# Rezoning Petition 2020-138 Pre-Hearing Staff Analysis December 21, 2020

### **PLANNING STAFF REVIEW**

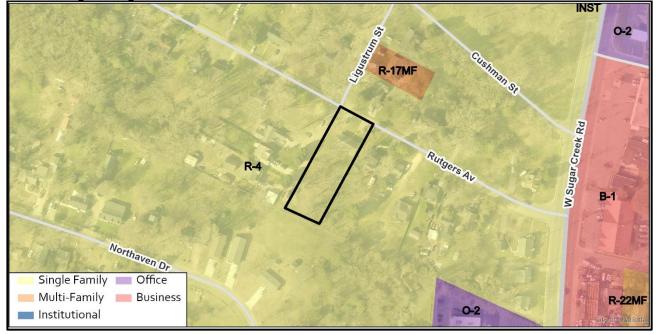
- 1. Revise site plan and conditional note(s) to commit to construct an 8-foot planting strip, on Rutgers Avenue and Ligustrum Street, per Chapter 19 of the City Code and required within Chapter 9 of the Zoning Ordinance.

- 2. Add site plan note(s) specifying dedication and fee simple conveyance of all rights -of-way to the City before the site's first building certificate of occupancy is issued. CDOT requests rights -of-way set at 2-feet behind back of sidewalk where feasible.

- 3. Add site plan note specifying that all transportation improvements will be approved and constructed before the site's first building certificate of occupancy is issued. The petitioner may phase transportation improvements if said improvements and phasing are explicitly described in site plan notes.

- 4. Revise site plan and conditional note(s) to commit to providing two accessible ramps at the intersection corner of Rutgers Avenue and Ligustrum Street.

5. Add note that site must comply with the City of Charlotte tree Ordinance.
